A REQUEST FOR A CONCEPT PLAN REVIEW APPROVAL

BY: Peacock Properties LLC
FOR: Mountain Legends Ranch Subdivision
WHERE: NE of Driggs, along N. Stateline Rd.
Planning & Zoning Commission
PREPARED FOR: Public Hearing of July 12, 2016

REQUEST: Peacock Property LLC is proposing a 76 lot subdivision on two parcels of land (approximately 197 acres) north of Driggs. The lots will be 2.5 acres, with approximately 100 acres in open space easements. These parcels are zoned A-2.5.

Figure 1: South parcel - Driveways that must meet local road standards or could be required to meet local road standards

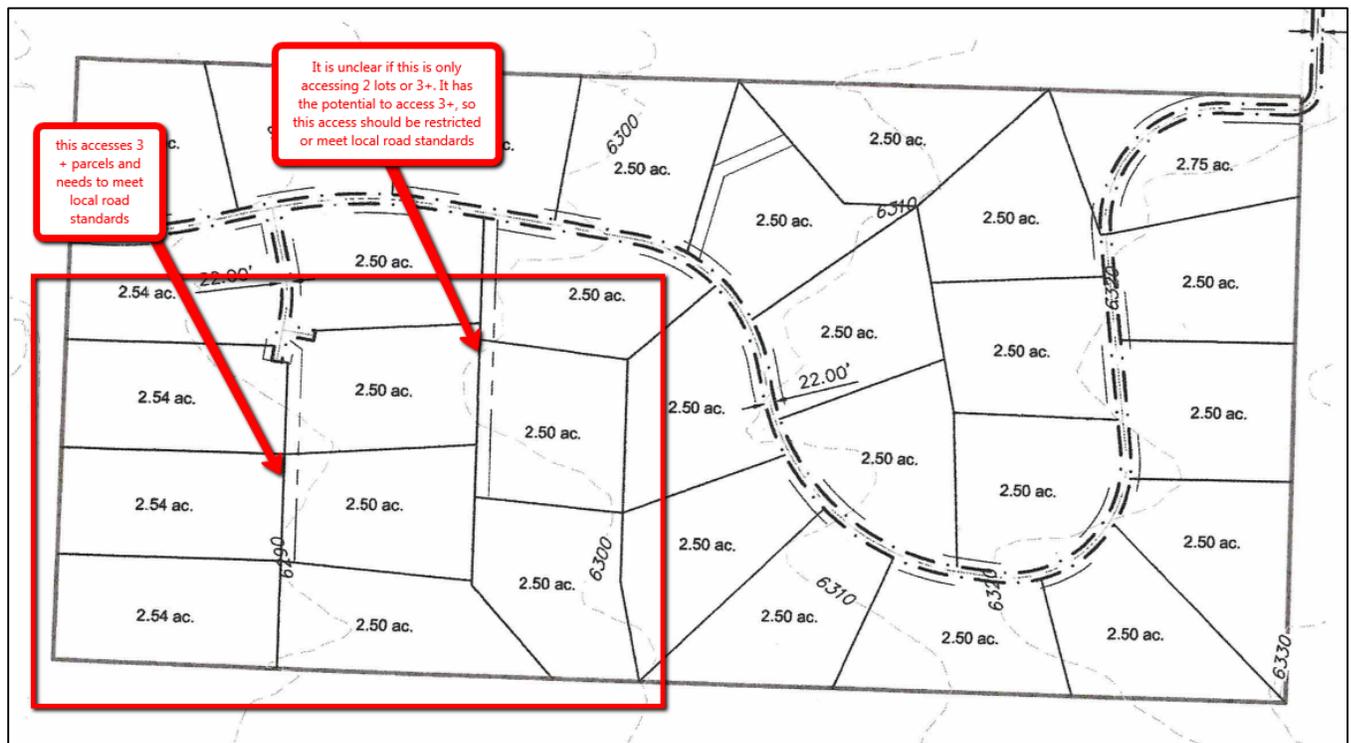
The Teton County Highway and Street Guidelines require that a driveway that accesses three or more parcels has to meet local road standards. Because of this requirement, the road must be extended, with the road surface area being removed from the lot areas. The parcels shown in Figure 1 below have the potential to access from different locations, so both should be designed as a local road, or a restriction should be added stating where the parcels are accessed from. However, at least one of the easements identified in Figure 1 has to meet local road standards because 3+ lots are being accessed.

1. Provide an updated plan with the public road right of ways of N. Stateline Road and N 1500 E removed from the lot areas, the addition to the subdivision road with the road surface removed from the lot area, and include an updated number of lots proposed for this subdivision.

Figure 2: North parcel - shared driveways

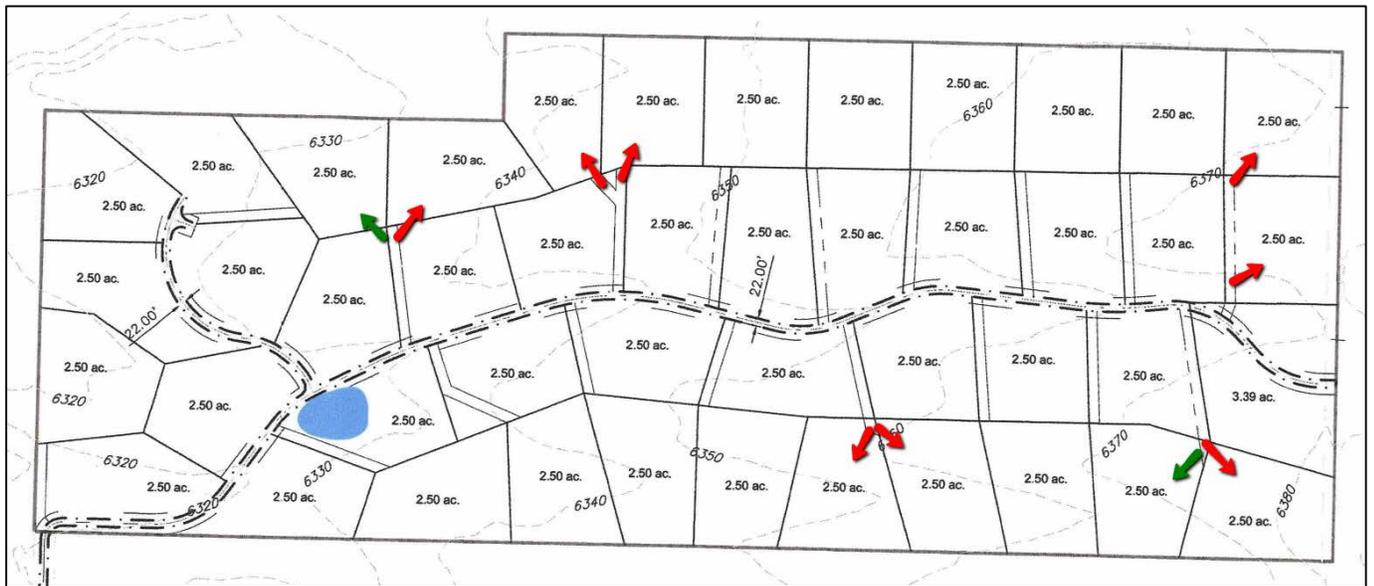
In Figures 2 and 3, the red arrows indicate parcels accessed by a driveway easement that would access at least two parcels. These would require a street name. The green arrows indicate a potential second parcel that could be accessed from the shown easement, which would then require a street name. The parcels with green arrows have another access option, so a restriction on the access location could clarify this and reduce the number of street names required. If the parcels that front the main subdivision road are not required to access from that road, the potential for more street names would increase significantly.

Figure 3: South parcel - shared driveways

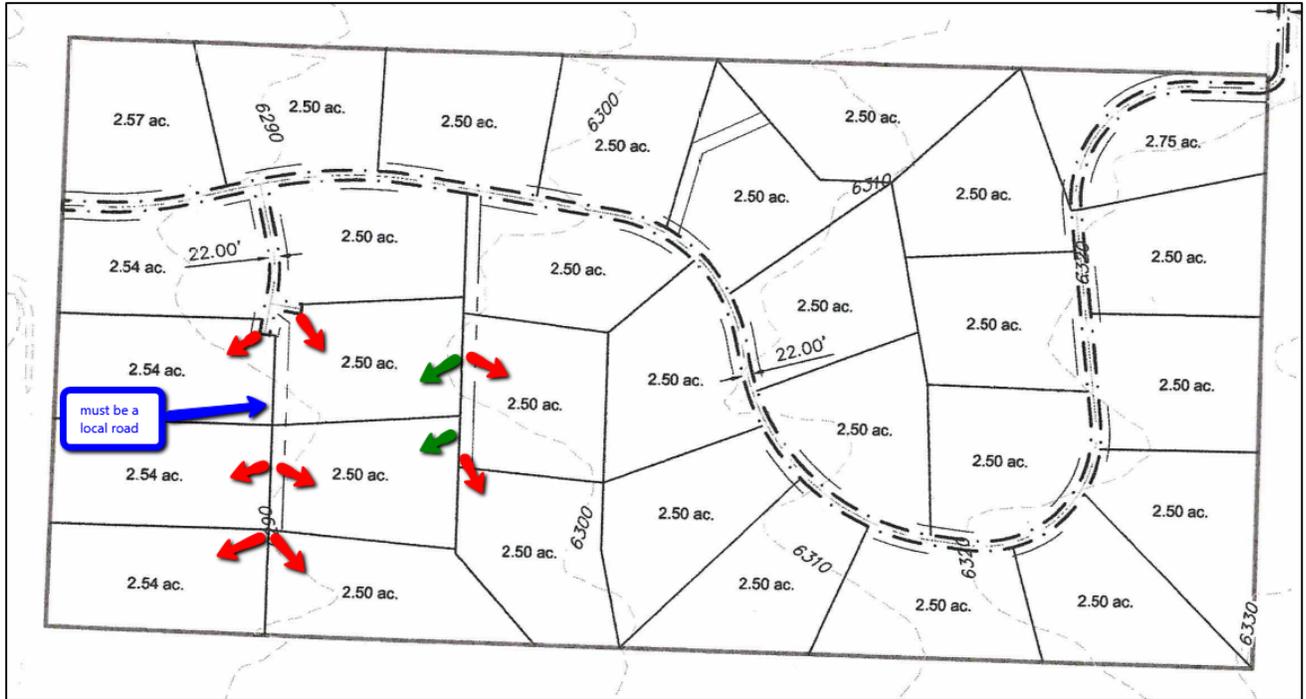
Assuming that every lot in the development that fronts the main subdivision road would access directly from the main road, there are 4 shared driveways that would require a unique street name for addressing purposes. One of these could be required to meet local road standards. There are two additional driveways that could provide access to two parcels, which would require a street name. Restrictions could be identified to only access one parcel, but because they are not, it is assumed they have can access two lots. This means there are 6 additional street names that would be required for this development. There is a seventh driveway easement that would access more than two parcels, but I did not include it, as I identified it above as needing to be a local road.
